Errata to MPC8569E PowerQUICC III Integrated Processor Reference Manual, Rev. 2

This errata describes corrections to the *MPC8569E PowerQUICC III Integrated Processor Reference Manual*, Revision 2. For convenience, the section number and page number of the errata item in the reference manual are provided. Items in bold are new since the last revision of this document.

Figure 8-22. DDR Write Leveling Control Register (DDR_WRLVL_CNTL)

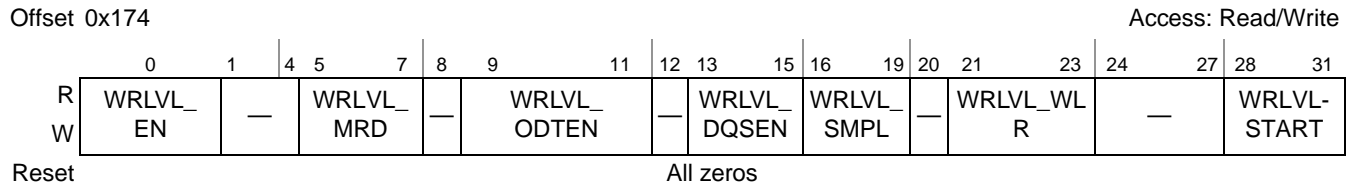
8.4.1.21, 8-42 In Figure 8-22, “DDR Write Leveling Control Register (DDR_WRLVL_CNTL)”, update the bit range for WRLVL_START from 27–31 to 28–31. The updated figure is shown below:

In addition, for Table 8-27, “DDR_WRLVL_CNTL Field Descriptions”, update the bit range for Reserved from “24–28” to “24–27” and WRLVL_START bit range from “27–31” to “28–31”.

Figure 16-26. Flow Chart for Reset of eSDHC

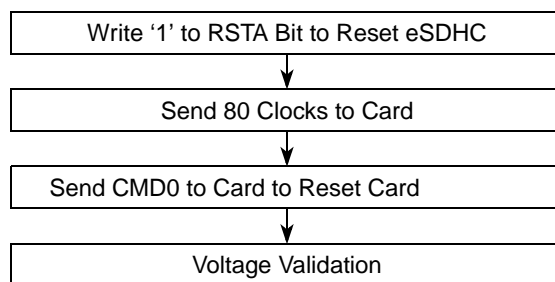
16.6.2.2, 16-46 In Figure 16-26, “Flow Chart for Reset of eSDHC”, update the caption to “Flow Chart for Reset of eSDHC” and replace with the following figure:

In addition, replace the pseudocode with the following:

```
software_reset()
{
    Configure the I/O muxes to select SD signals;
    set_bit(SYSCTL, RSTA); // software reset the host
    set SYSCTL[DTOCV and SDCLKFS]; // get the SDHC_CLK of frequency around 400 kHz
    poll PRSSTAT[CIHB and CDIHB]; // wait until both bits are cleared
    set_bit(SYSCTRL, INTIA); // send 80 clock ticks for card to power-up
    If the card is SD/MMC
        send_command(CMD_GO_IDLE_STATE, <other parameters>); // reset the card with CMD0
}
```
